UNITED STATES PATENT AND TRADEMARK OFFICE

APPLICATION NO.	FILING DATE	FIRST NAMED INVENTOR	ATTORNEY DOCKET NO.	CONFIRMATION NO.
10/789,357	02/27/2004	John Popovich	PERMLT.019C1	5148
20995	7590	08/25/2005	EXAMINER	
KNOBBE MARTENS OLSON & BEAR LLP 2040 MAIN STREET FOURTEENTH FLOOR IRVINE, CA 92614			TSO, LAURA K	
			ART UNIT	PAPER NUMBER
			2875

Office Action Summary

DETAILED ACTION

FIG. 16

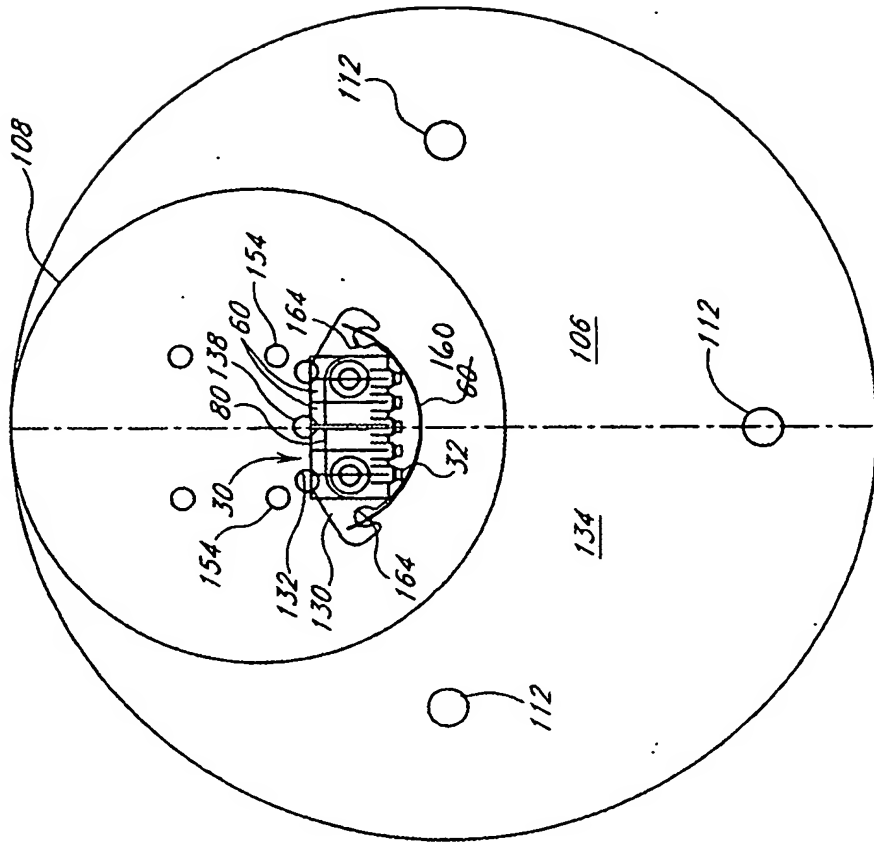
The drawings are objected to because in figure 16, applicant should change "60" to ~~160~~ (note attachment). Corrected drawing sheets in compliance with 37 CFR 1.121(d) are required in reply to the Office action to avoid abandonment of the application. Any amended replacement drawing sheet should include all of the figures appearing on the immediate prior version of the sheet, even if only one figure is being amended. The figure or figure number of an amended drawing should not be labeled as "amended." If a drawing figure is to be canceled, the appropriate figure must be removed from the replacement sheet, and where necessary, the remaining figures must be renumbered and appropriate changes made to the brief description of the several views of the drawings for consistency. Additional replacement sheets may be
